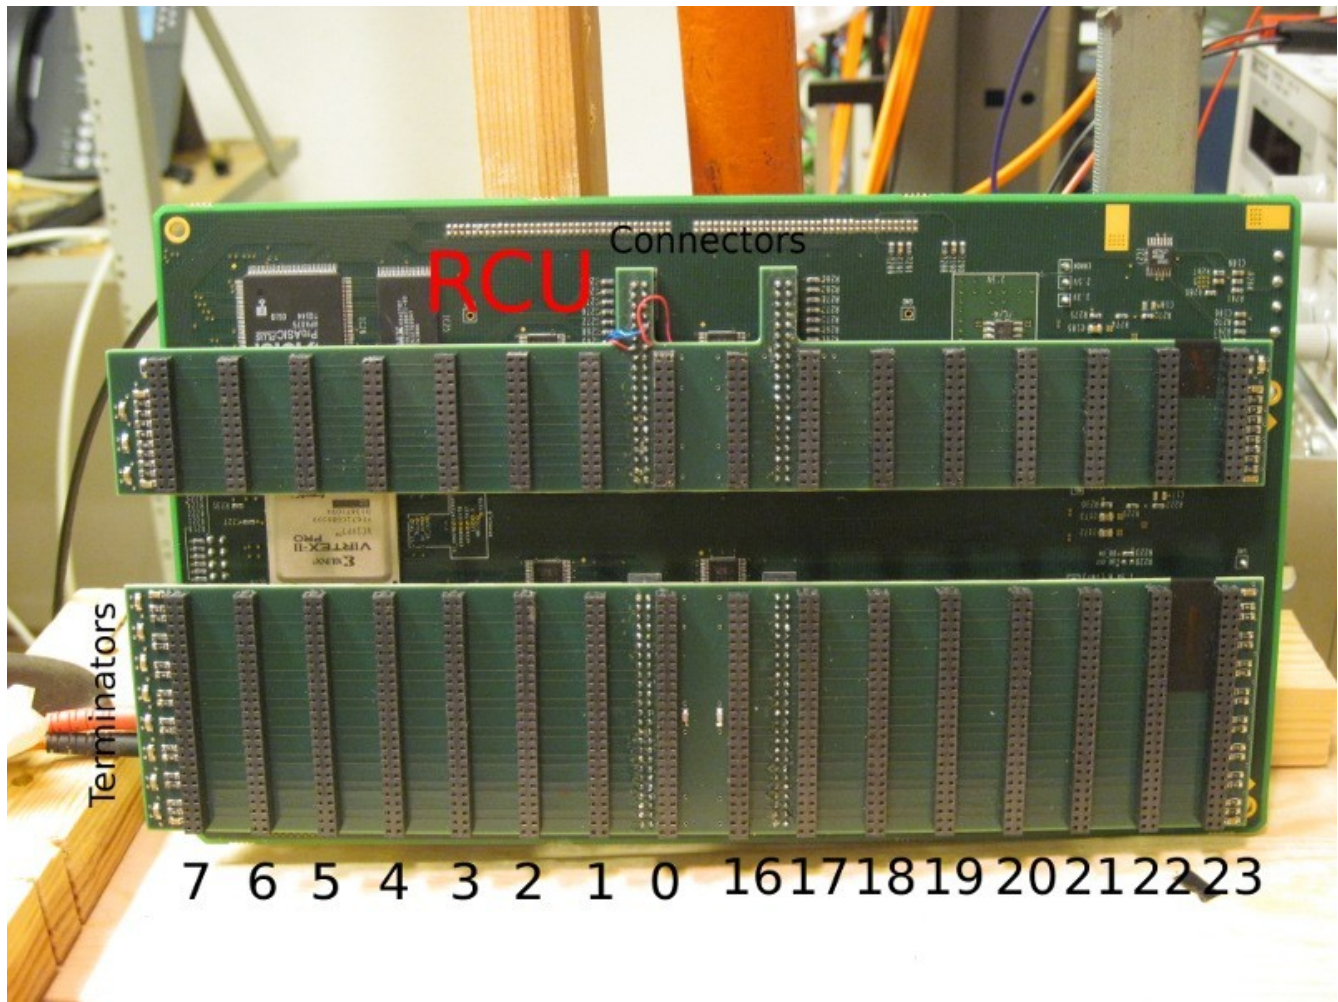
There are 16 FEC slots, eight one each side, available slots are 0-7 and 16-23, numbered as in the figure, where the RCU is seen from the backplane side (slot 7-0 is LEFT. 16-23 is RIGHT). Slots 8-15 and 24-31 do not exist.

The backplanes are slightly misaligned with respect to the center of the RCU, it is shifted by ca 1 cm to the LEFT (should not be serious, since the optical cable is requiring more space than the shift).

There were two mistakes on the backplane. Some of the slots were interchanged. These have been corrected for by cutting some lines, replacing with wires (lines used to power on the FEC) or for address lines by cutting and shorting pins.

Interchanged were power on lines:

0 5 should be 4 5

2 1 should be 2 3

4 3 should be 0 1

slot 0 ↔ slot 4

slot 1 ↔ slot 3

Each slot has also its own fixed address that were interchanged, fixed by:

Slot 0 ↔ Slot 4

Slot 1 ↔ slot 3

Fixed by cutting the power on lines and connecting with wires.

pin 20 was cut in slot 4, and shorted with 19 in slot 0.

pin 19 was cut in slot 3, and shorted with 20 in slot 1.
